Ductor Roll Upgrade Kit

for the Stolle Rutherford Decorator

Technical Update 1206-2

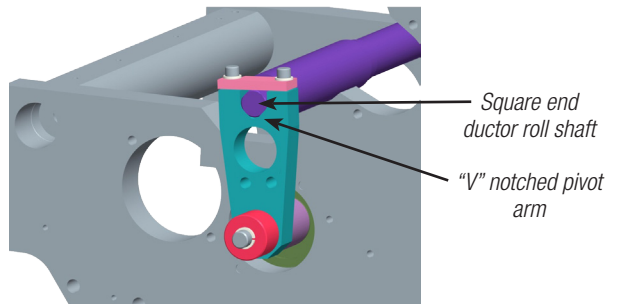
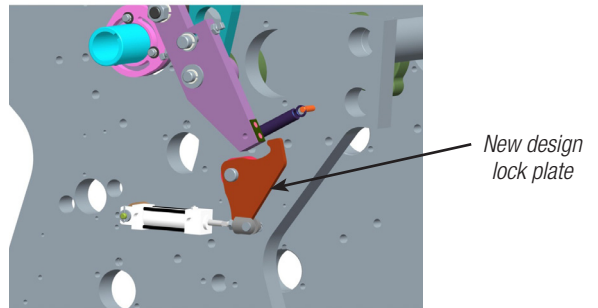
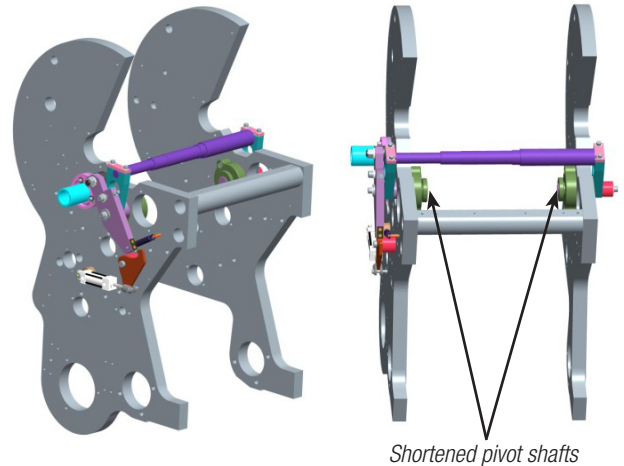
Stolle has developed an upgrade kit for the Rutherford Ink Station that will improve the performance of the ductor roll assembly. The Ductor Roll Pneumatic Lock Plate and Pivot Shaft Upgrade Kit will provide a number of benefits in terms of reduced maintenance, easier use and improved print quality.

- New pneumatic lock plate design provides a more positive engagement on the ductor pivot arm to lock out the ductor when not in use.
 - Eliminates the buildup of ink while the inker is idle due to loss of engagement of the lock plate.
 - Reduces wear on the lock plate as well as the wear plate on the pivot arm.
- Full pivot shaft has been replaced with two short pivot shafts.
 - Full pivot shaft can catch ink sling requiring cleaning to prevent ink from dripping back onto rolls. Elimination of this shaft across the inker reduces the maintenance requirements as well as reduces opportunities for print defects.
- Square ends on ductor roll shaft positively locate and rigidly mount in "V" notches in the pivot arms.
 - Rigid mounting eliminates the need for parallel adjustments on the ductor roll shaft.

This retrofit kit will install in CD2 basic style inkers with no rework required. Installation in CMP style inkers will require some rework to accommodate the flanged bearings.
